TRANSMITTAL OF NINTH TAAG REPORT - Hmb-212-84

NINTH REPORT
OF THE
Technical Assistance and Advisory Group (TAAG)

Three Mile Island Unit 2 (TMI-2)
For the Period April 1, 1984 to August 1, 1984

FIGURE 8-1

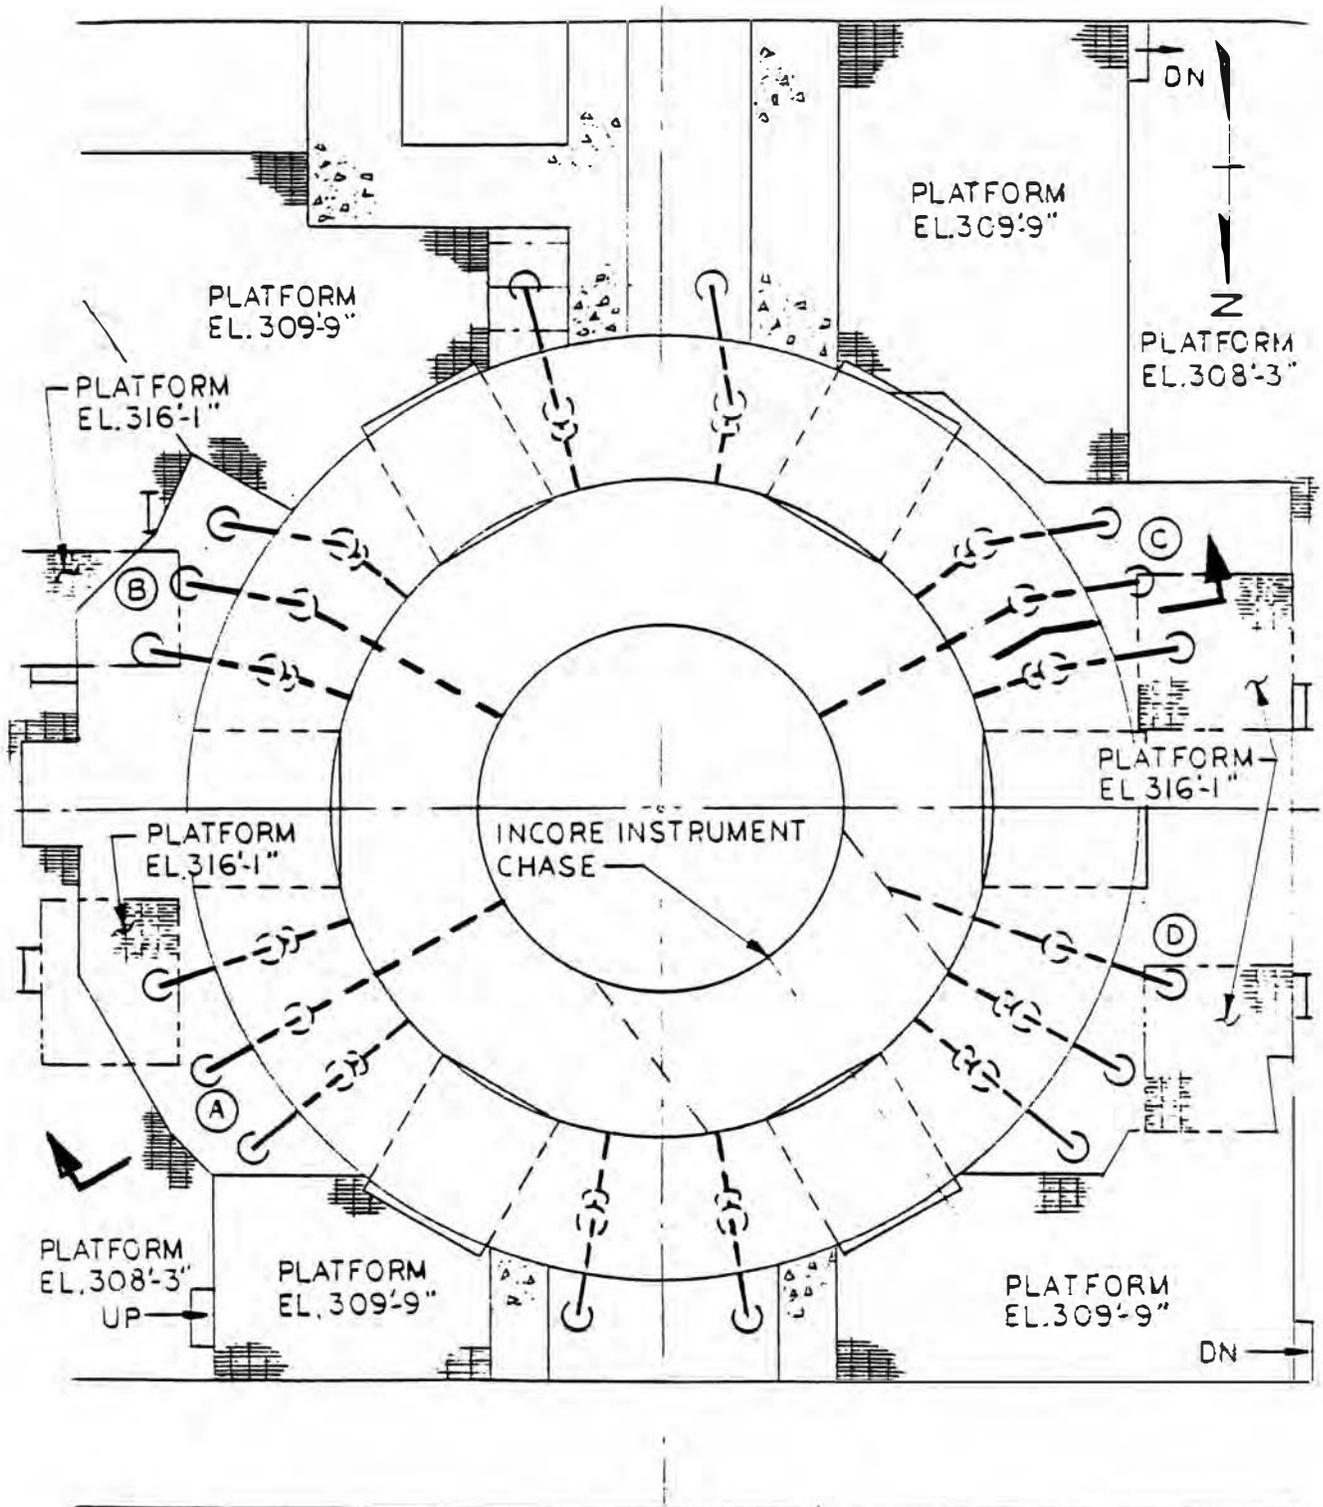
Twelve of these ducts terminate above the support skirt of the reactor vessel. Four of these ducts terminate at elevation 283'3", beneath the reactor vessel (see Figure 8-1). Three of these ducts terminate 6'3" from the centerline of the reactor vessel (labelled A, B, and C on Figure 8-2). The fourth (labelled D on Figure 8-2) is cut flush with the side of the in-core instrument chase.

These ducts could be used to introduce radiation instruments into the area below the lower reactor vessel head. The inside diameter of 14" schedule 30S pipe is 13.25 inches. This should be large enough to accommodate a wide range of instruments, including closed-circuit television cameras, without difficulty.

These ducts could provide a mechanism for refining the lower bound estimate of fuel debris on the bottom of the RV. This estimate was developed by HEDL using the solid-state track recorders (SSTRs). HEDL used the neutron flux from the lowest SSTR in the vessel cavity as the neutron flux beneath the reactor vessel. This was admittedly conservative in that it resulted in less predicted fuel. If a neutron detector were actually introduced into the area beneath the reactor vessel, that data combined with the SSTR analysis would raise the estimate of the lower bound for the fuel debris on the lower head.

Another possible examination using these ducts is to view the condition of the in-core guide tubes. Also, watching for leakage using CCTV cameras could provide a more direct indication than is currently possible in the unlikely event of small leaks from the bottom of the RV.

However, the access to the platform on elevation 308'3" is complicated by the fact that many of the ladders planned were not installed to expedite the completion of the plant's construction. The platform at El. 308'3" is accessible only from the basement with the currently installed ladders. Temporary ladders could eliminate this concern, but, due to the dose rates in the D-rings, would impose a worker exposure penalty while rigging the ladders in position. Also, dose rates at the accessible ends of the ducts are approximately 1R/hr. Hence, any data acquired via these ducts would be at a relatively large worker exposure. TAAG does not see any data acquisition, at present, worth the worker exposure involved with working in 1R/hr dose rates. However, if the need arises, the avenue exists to survey and to view the reactor vessel cavity beneath the lower head and the in-core guide tubes.

FIGURE 8-4
HVAC DUCT WORK ACCESS ROUTES

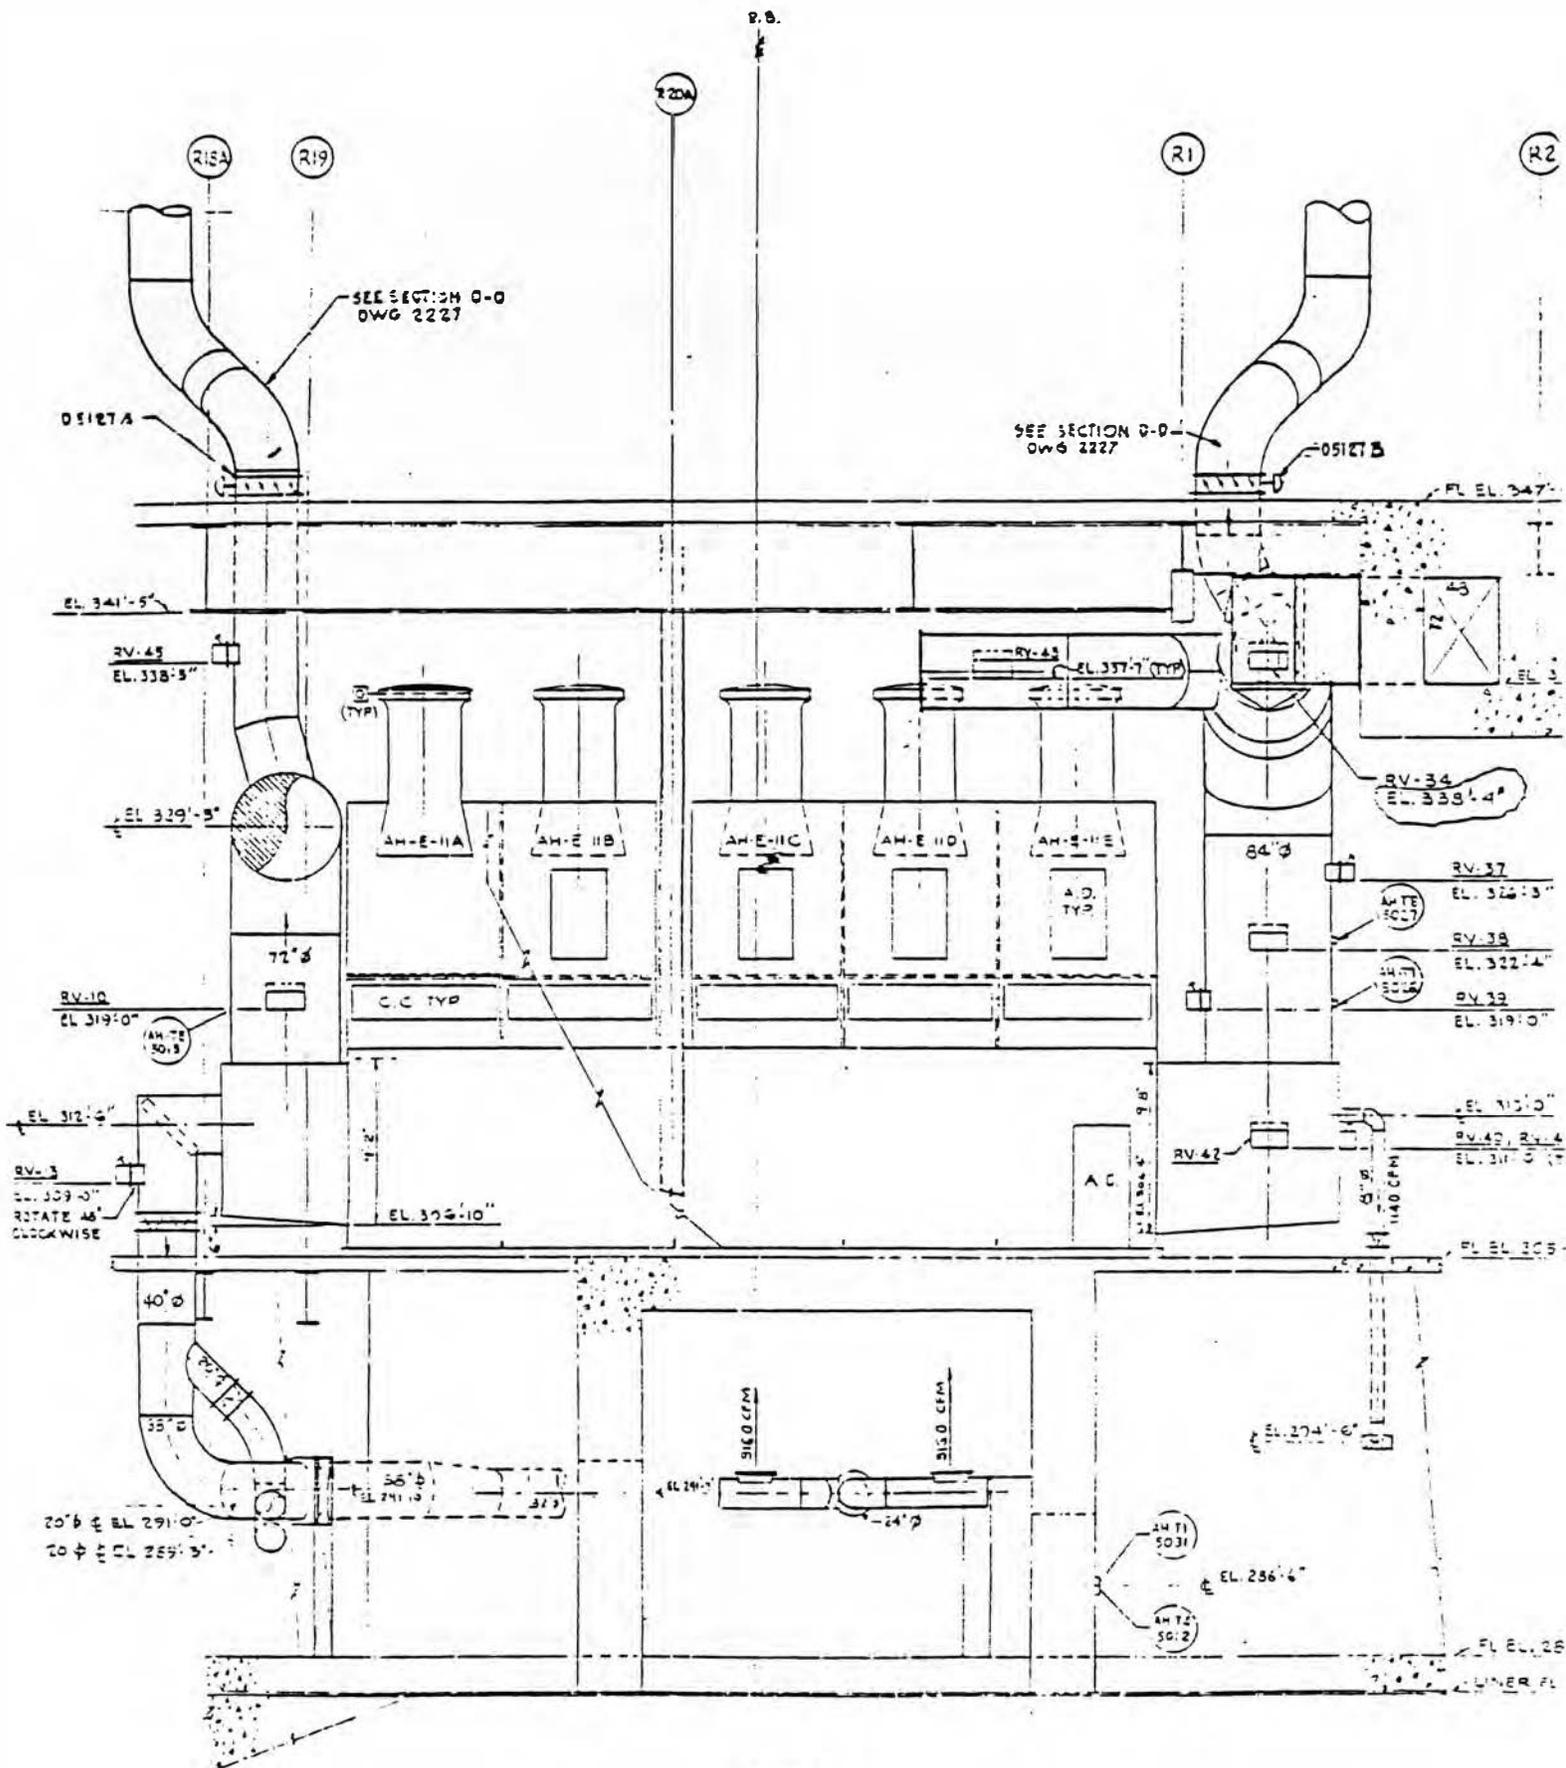
Figure 8-3 shows the layout of the HVAC duct work in the RB basement. It can be seen from this drawing that the duct work is relatively level and that it enters into the letdown coolers cubicle. A relatively simple robot, similar to the type used to inspect gas lines, could be used to take a gamma spectrometer to the letdown coolers cubicle. The access to this duct is through the duct work attached to the east end of the RB cooling fans air plenum. One balance damper in the 20" duct (see Figure 8-4) must be either cut or negotiated by the robot, but no other obstacles are present.

This pathway is complicated but it may be the only ALARA way to obtain data about the contents of the letdown coolers in the foreseeable future.

FIGURE 10-1
SECTIONAL VIEW OF EQUIPMENT HATCH

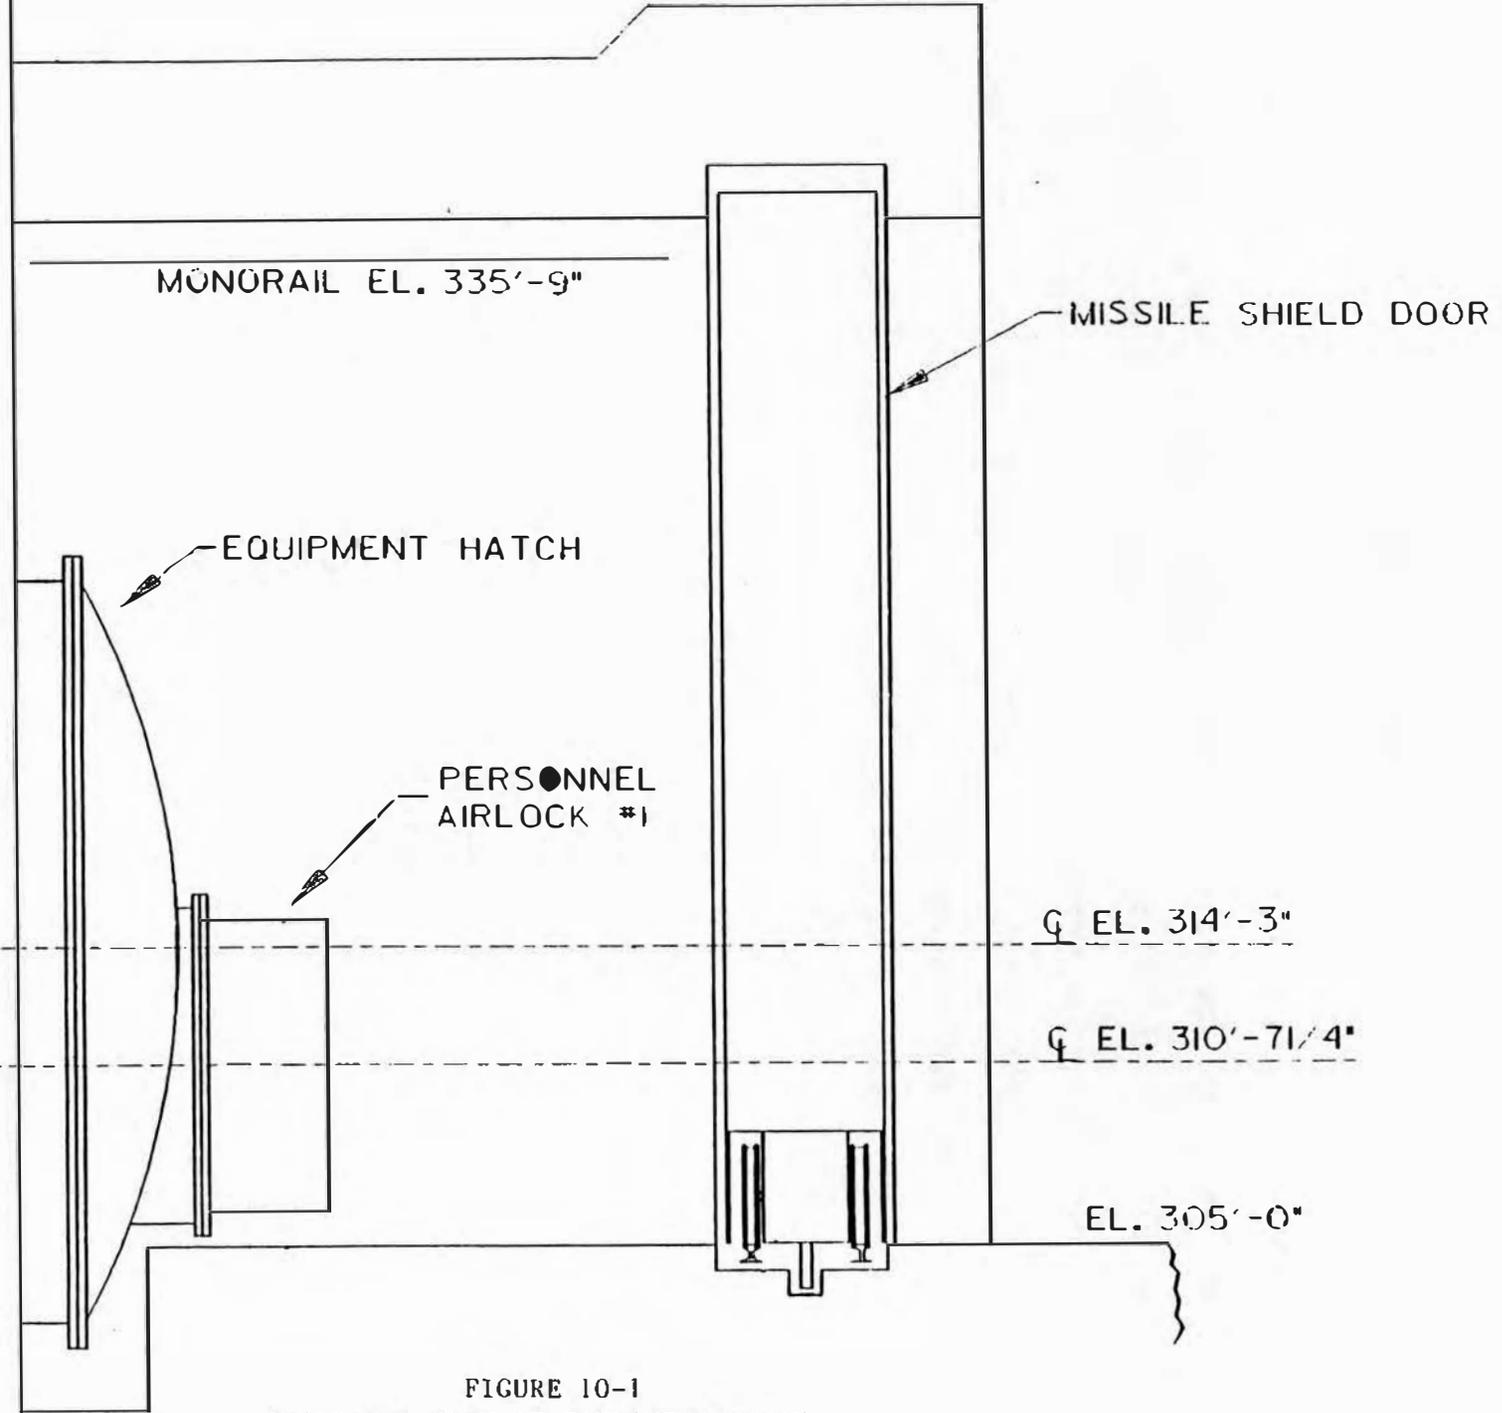
The equipment hatch is located in the southwest quadrant of the reactor building. It is a 23' diameter penetration in the reactor building wall and is provided to permit the movement of large objects into and out of the reactor building during an outage. A removable personnel air lock (air lock #1) is incorporated into the equipment hatch. Both the hatch and the air lock are double gasketed and bolted to steel flanges in the building. The seal is designed to withstand the effects of design basis accidents. Figure 10-1 shows a sectional view of the equipment hatch, the personnel air lock, and the missile enclosure.

The procedure for removing the equipment hatch requires that the personnel airlock be removed first. This airlock assembly can be withdrawn intact, utilizing the monorail installed in the missile shield enclosure. The 9' outside diameter, 12'6" long airlock weighs 15 tons and is provided with lifting lugs to facilitate its removal. Once the personnel air lock is removed, the equipment hatch can be opened. The equipment hatch is 24'8"

outside diameter and weighs 20.5 tons. It cannot be removed using the installed monorail because there is not adequate head room to permit the hatch to be lifted over the recess in the control building roof slab (see Figure 10-2). The equipment hatch has to be removed using cherry pickers or some other sort of temporary lifting equipment.
